Appendix 9 – Evidence of Kevin Kemp on the Flood Assessment Overlay

of the Proposed Timaru District Plan

STATEMENT OF EVIDENCE BY KEVIN THOMAS KEMP

Figure 1

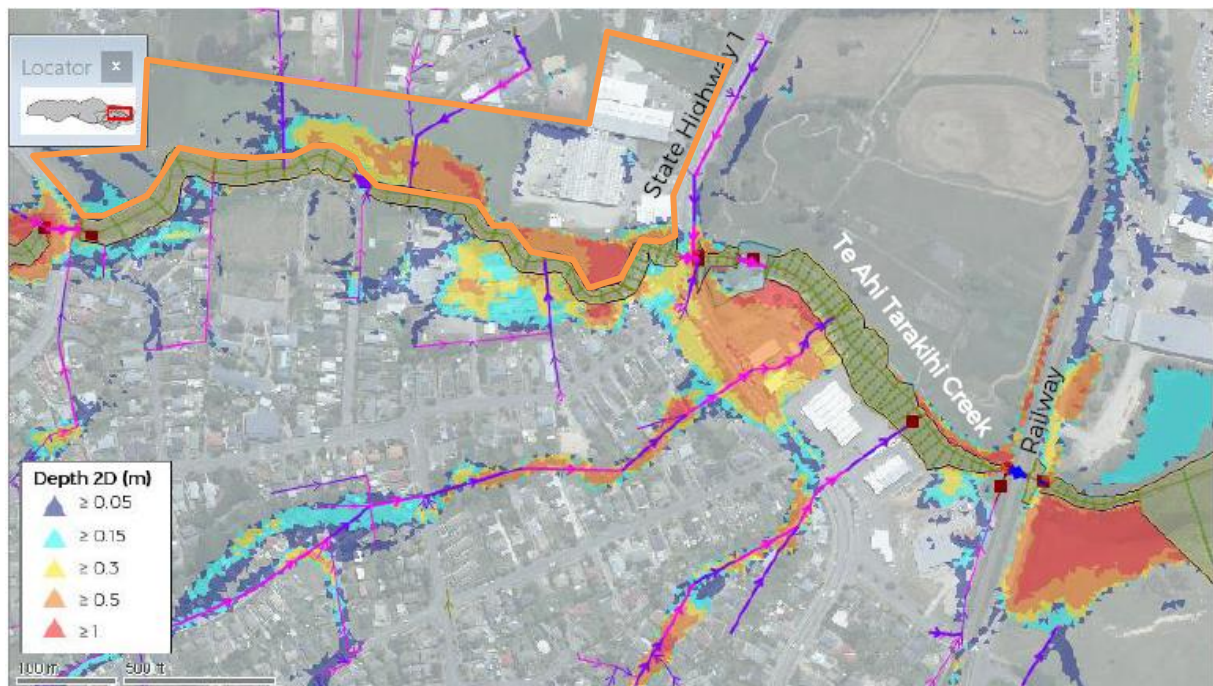
- 30 Since the PDP model output was produced, TDC has engaged WSP to undertake a full model build of the Te Ahi Tarakihi sub-catchment of the Timaru Urban area to TDC's Stormwater and Wastewater Model Build Specification, incorporating the new culverts at State Highway 1 and the KiwiRail Corridor.
- 31 The model build specification includes detailed requirements for consideration of Climate Change, specifically the use of the 2090 RCP8.5 climate change scenario which includes a sea level rise 1.18m and storm tide of 2% AEP.
- 32 In March 2024, WSP supplied TDC with updated modelling results, supplying multiple scenarios for various rain events and with consideration for the full 2090 RCP8.5 climate scenario and without.
- 33 Figure 1 below gives an indication of the extents of a 0.5% AEP flood event with no Climate Change.

- 34 Comparing Figure 1 above with Figure 4A from the PDP evidence, the extents match up relatively accurately.
- 35 Figure 2 below shows the 0.5% AEP Event with Climate Change from TDCs updated model.

Figure 2

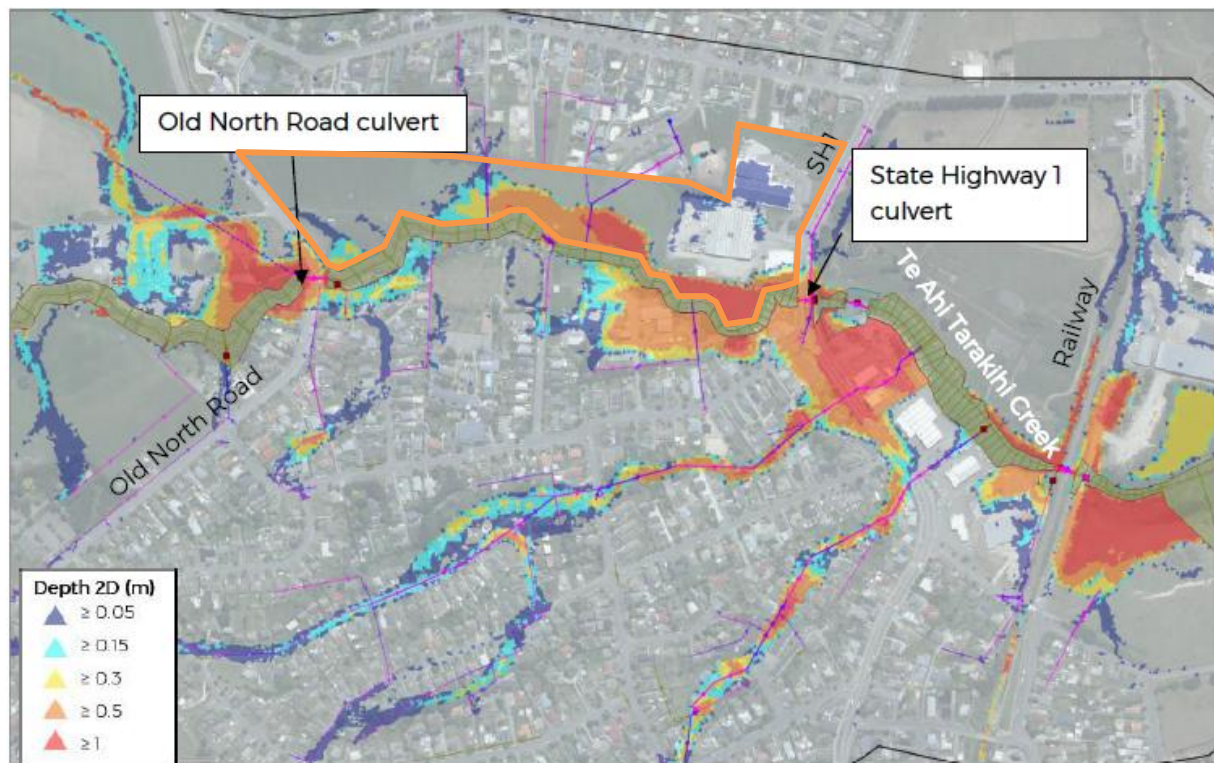
- 36 The differences between Figure 2 and Figure 1 is an increase in flood depths within the margins of Te Ahi Tarakihi Creek and an increase in localised flooding within the Harvey Norman Site.
- 37 Based the topography of the Harvey Norman site and the surrounding residential area to the north, in the event of a 0.5% AEP rain event, localised flooding on the site may be experienced.
- 38 Figure 2 does indicate the flooding within the Harvey Norman building itself. This level of flooding may be plausible for the groundfloor, warehouse level of the site.
- 39 Figure 3 below provides an indication of the change of the Flood Assessment Area on the site with the Green area indicating the new Flood Assessment Area and the Blue indicative of the Notified Flood Assessment Area.

Figure 3

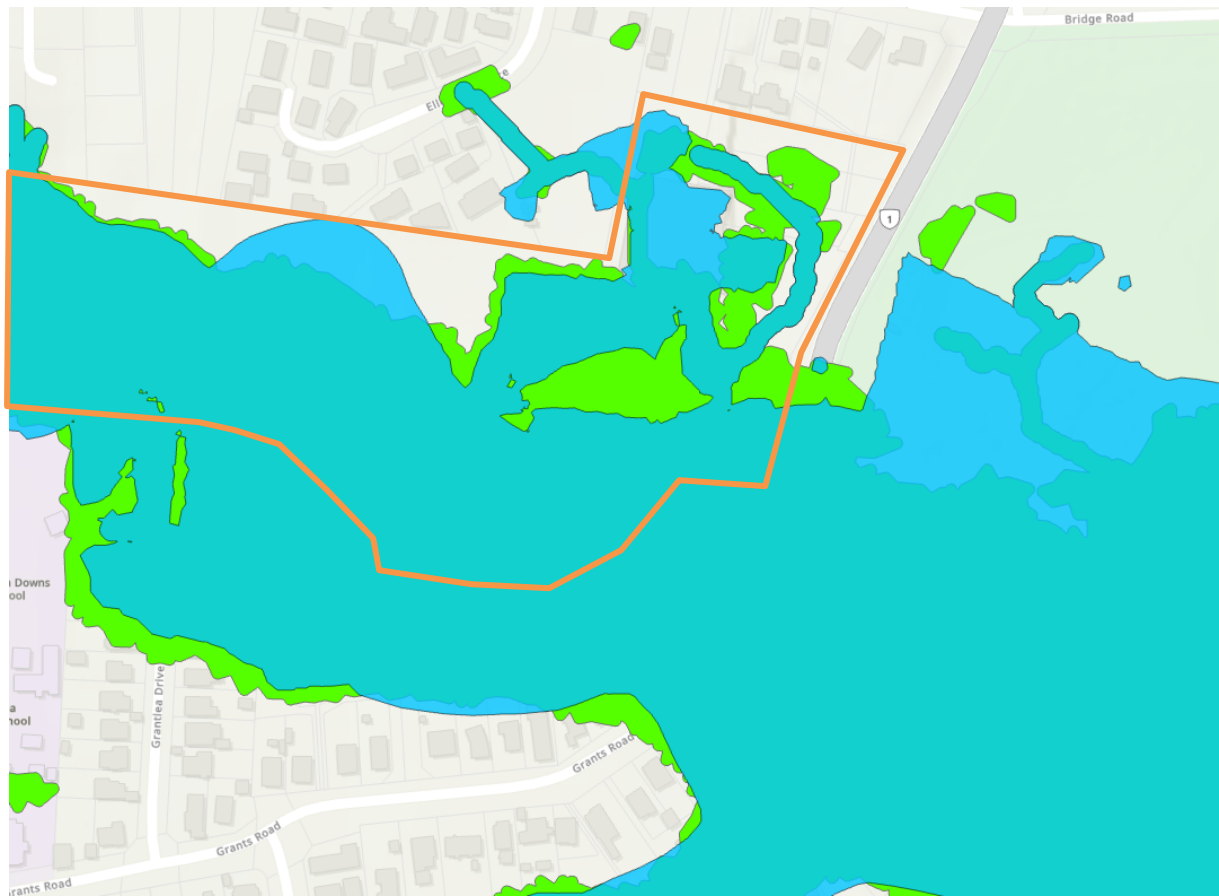
- 40 The Green Area can be seen (projected under the Blue Area) to now exclude the main Harvey Norman Building while continuing to cover the majority of the site (Parking area, lower lying warehouse and former PGG Wrightson's Building).
- 41 This is indicative of the higher elevation of the main Harvey Norman Building on the site.
- 42 Due this localised flooding within the Harvey Norman site identified by TDCs most current modelling of the Te Ahi Tarakihi catchment, I recommend that the submission to reduce the extent of the Flood Assessment Area Overlay be rejected.
